ASI-0106

Subject: TH-K20AK MARS / CAP Modification

Date: January 04, 2012

Fig 1

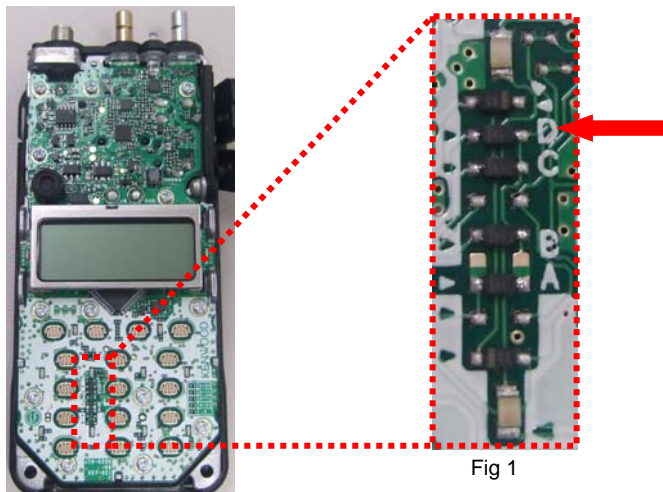
1. Turn off the transceiver and remove the battery pack.
2. Remove the antenna, channel selector knob, and volume knob.
3. Remove the Side Jack Accessory Cover.
4. Remove the two screws from the bottom of the radio on the back side.
5. Carefully lift the front panel up from the chassis, starting at the bottom of the radio. Be careful not to damage the speaker wires as you're opening the radio.
6. Locate and carefully remove Diode D411 Reference D from the TX/RX unit - (see Fig 1).
7. Assemble the transceiver.
8. Reset the radio.

Transmitter Operating Range: 142 ~ 151.995MHz
